MEMORANDUM

SUBJECT: New Basketball Court Markings.

This memorandum serves to communicate a rule change approved by the Women's Basketball Rules Committee and Playing Rules Oversight Panel (PROP) regarding the lower defensive box and required court markings.

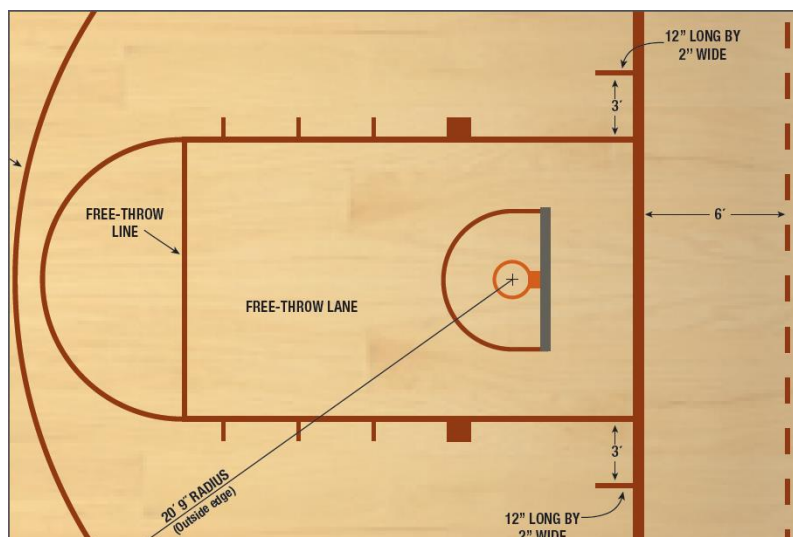
The change, which becomes effective with the 2013-14 season, requires institutions to add two 12" x 2" lines ("tick marks") on the baseline which are located 3 feet from the outside edge of the lane line. The tick marks should be measured from the outside edge of the lane line to the inside edge of the tick mark on both sides of the lane and on both ends of the court. The court diagram below may also be viewed at the following link: [Half Court Diagram](#)
